RE: ENGINEER CERTIFICATION FOR GOLDEN TARGET STORAGE (F20-D25)
CERTIFICATION STATEMENT DATED 7/1/96.

RE: REVISION TO GOLDEN TARGET STORAGE OUTFALL CONCEPT (F20-D25)
ENGINEER'S STAMP DATED 3/4/96.

RE: DRAINAGE PLAN FOR GOLDEN TARGET STORAGE (F20-D25)
ENGINEER'S STAMP DATED 9/19/95.

RE: RESPONSE TO YOUR COMMENTS DATED SEPTEMBER 28, 1995, FOR
GOLDEN TARGET SELF STORAGE

MODIFICATIONS TO EXISTING TYPE "E" MANHOLE

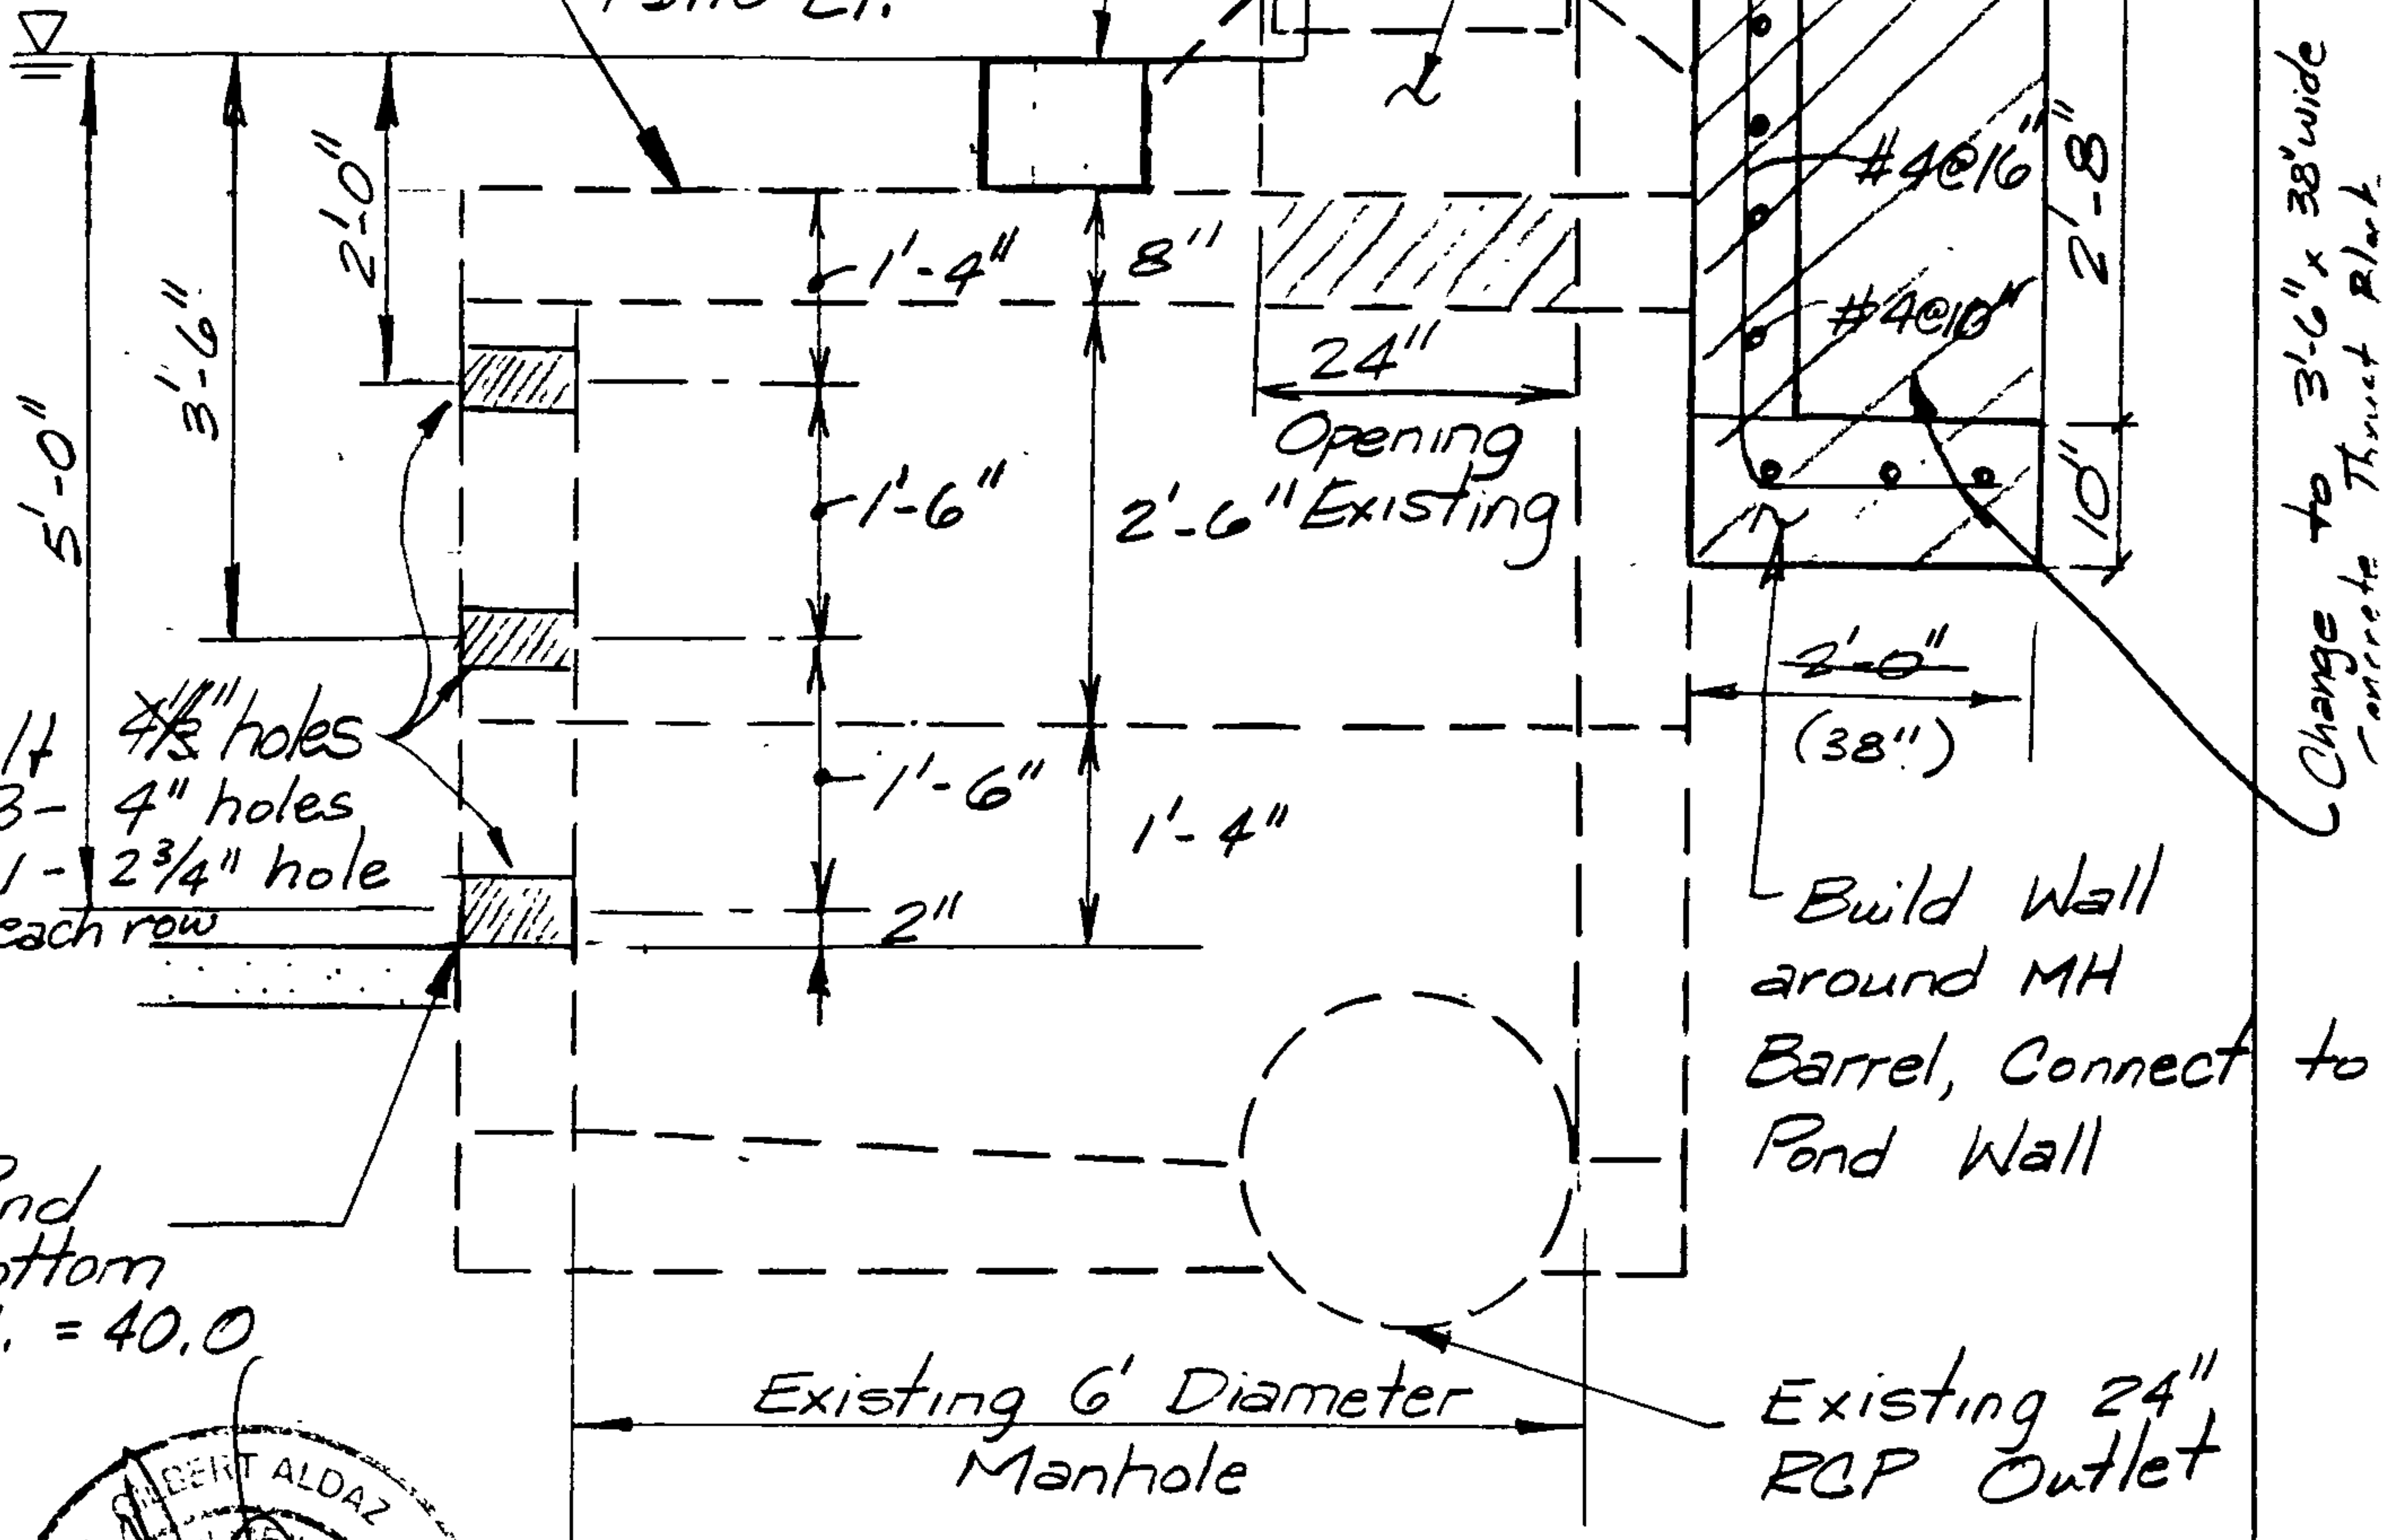
3-26-96/Revision No. 1: Change Wall & Footing to Monolithic Concrete Thrust Block 3'-6" x 38" Wide

Revision due to 4 $\frac{1}{3}$ " diameter bit not available

Due to Core Drills not available
with a diameter of $4\frac{1}{3}$ inches
Contractor was instructed and
drilled 3 - 4" holes and 1 - $2\frac{3}{4}$ "
hole due to availability of core bits.

Note: Contractor is to clean all exposed joints then grout or add joint sealant to assure a water tight seal for the existing manhole. The only openings allowed are the 9 - 4 1/8" diameter holes, and the existing 24" opening.

Check 3 - 4" and 1 - $2\frac{3}{4}$ " diameter

$$3 \times \frac{\pi (4")^2}{4} + \frac{\pi (2\frac{3}{4})^2}{4} = 43.6 \text{ in}^2 \approx 43.5 \text{ in}^2$$

MODIFICATIONS TO EXISTING TYPE "E" MANHOLE

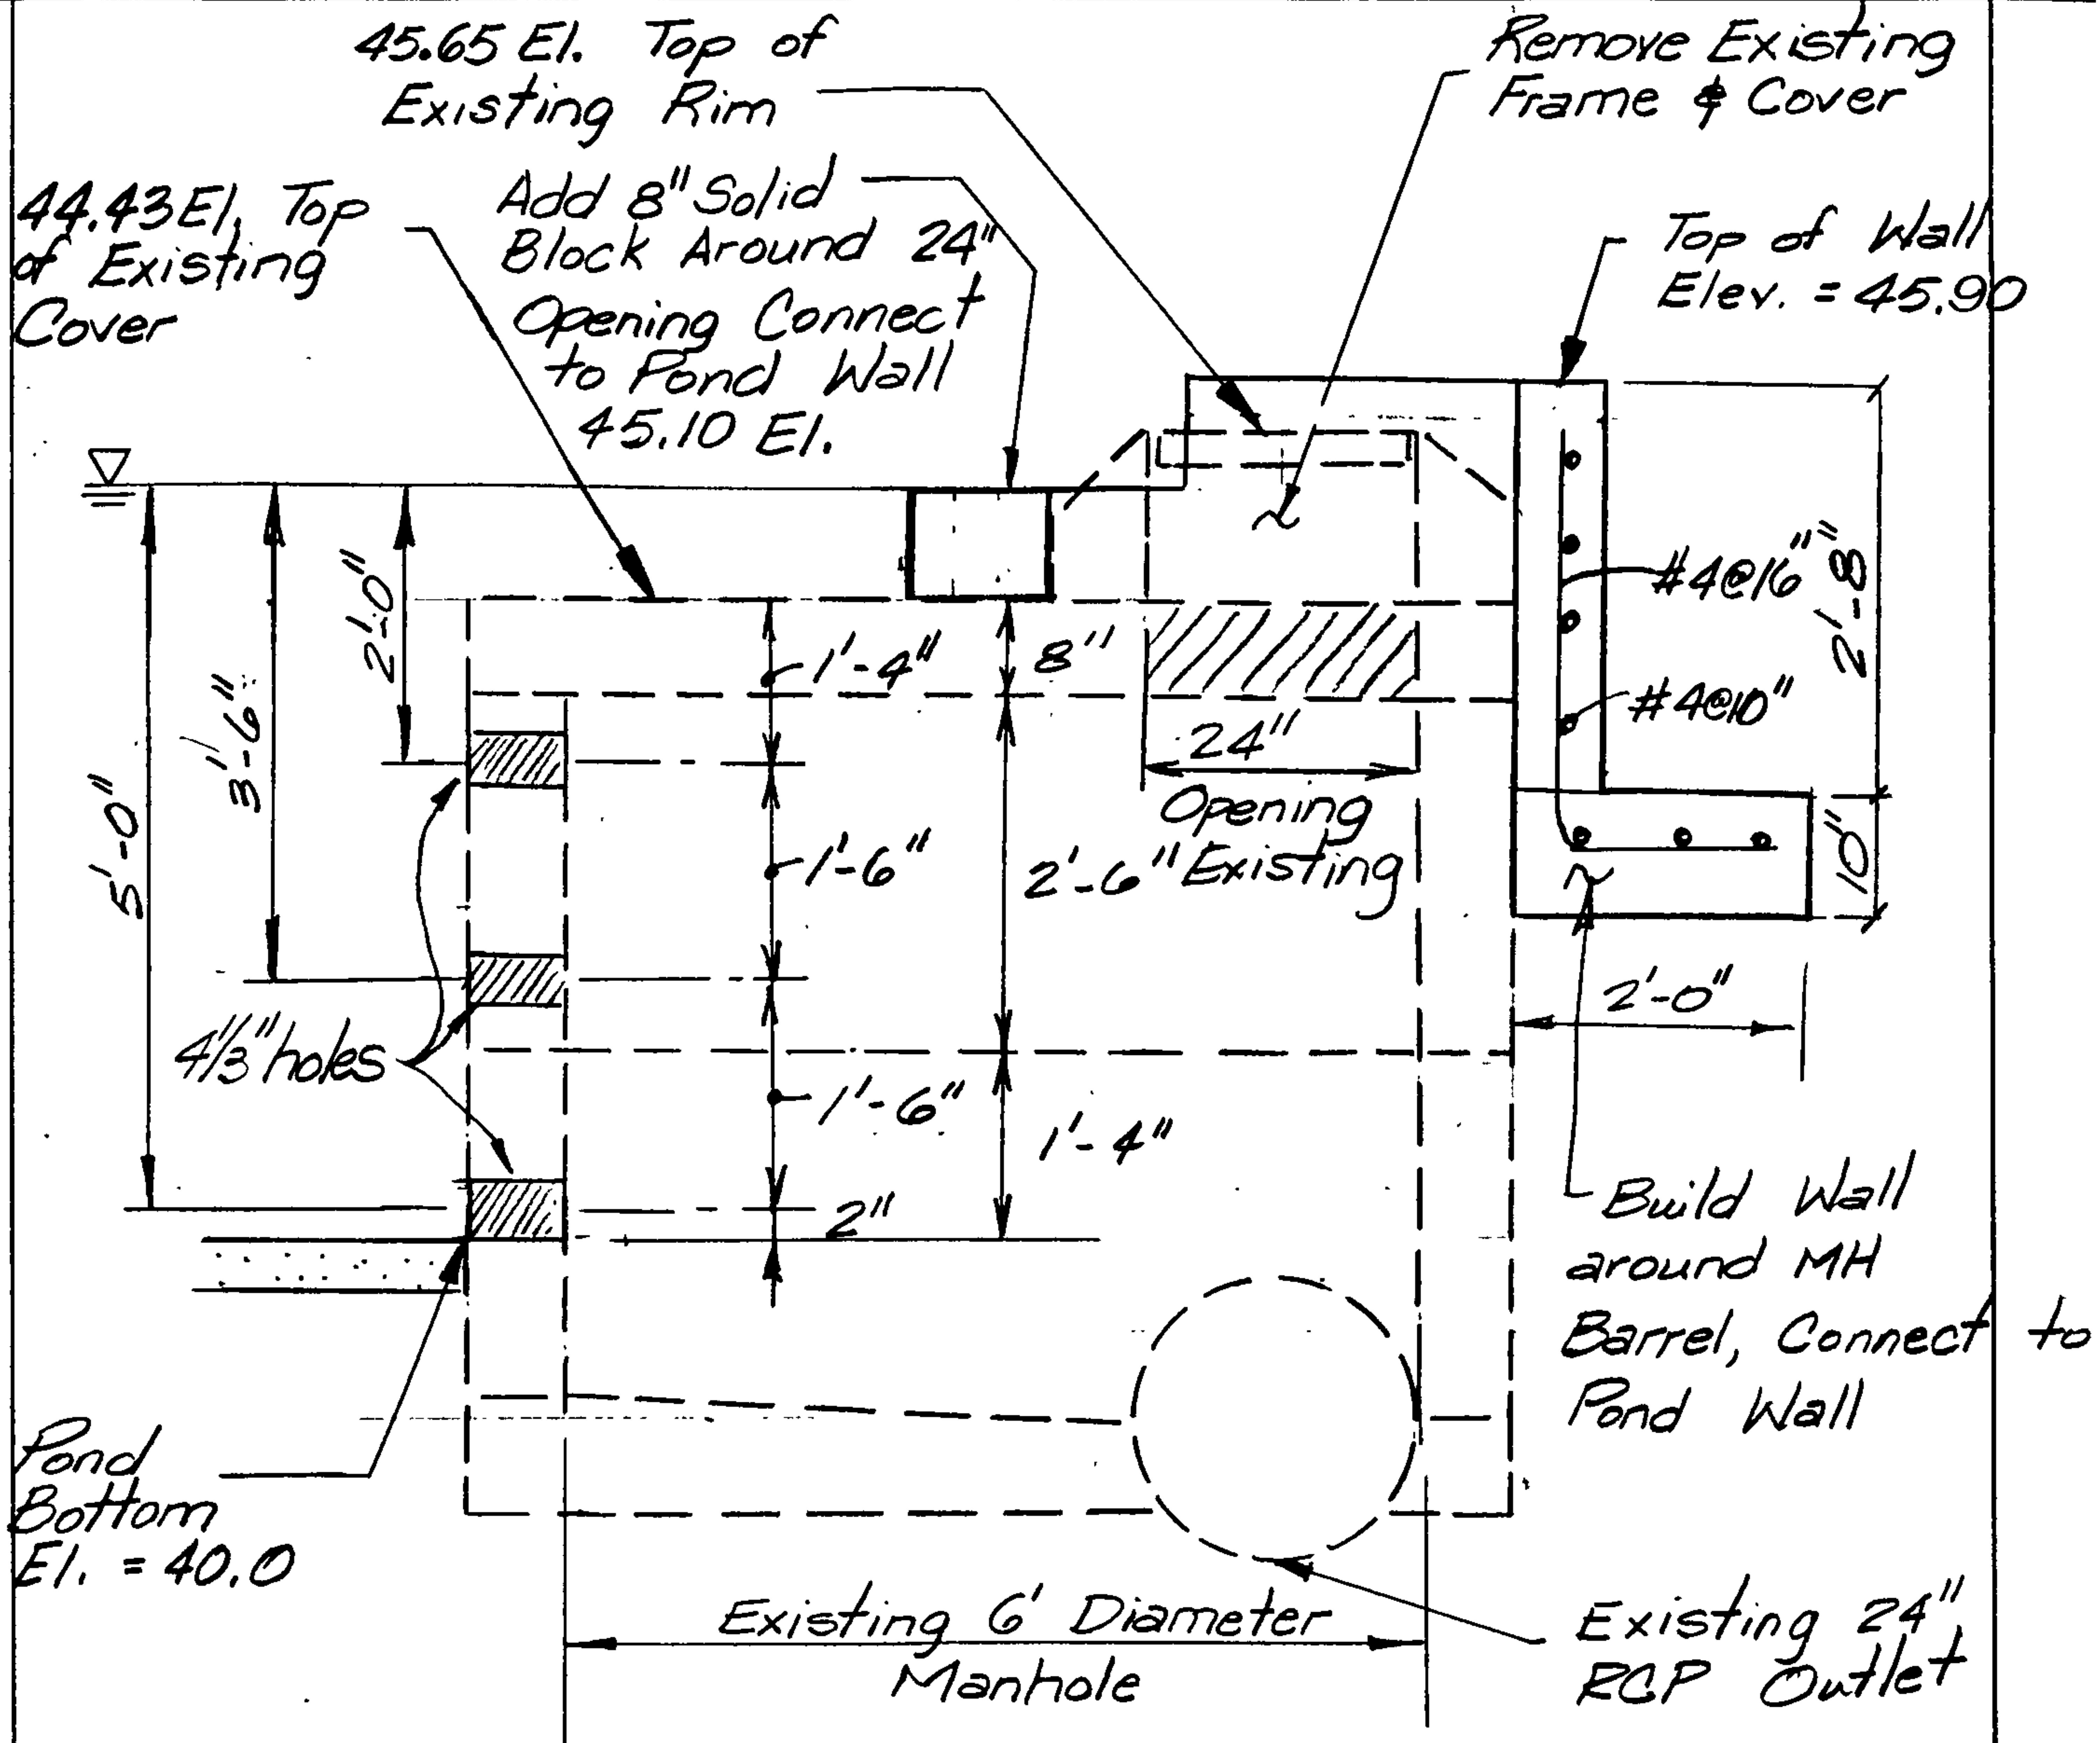
The manhole is a 6 foot diameter, type "E". Based on the attached calculations and re-sizing of the drilled holes for maintaining the orifice control, and raising the spillway elevation to account for the volume taken up by this existing manhole, the manhole will function appropriately. Due to the concrete contractor wanting to complete this work in the next couple of weeks we would appreciate a response as soon as practical, even a verbal.

Note: Contractor is to clean all exposed joints then grout or add joint sealant to assure a watertight seal for the existing manhole. The only openings allowed are the 9 - 4 1/3" diameter holes, and the existing 24" opening.

drill 3 - 4 1/3" diameter holes at each level.
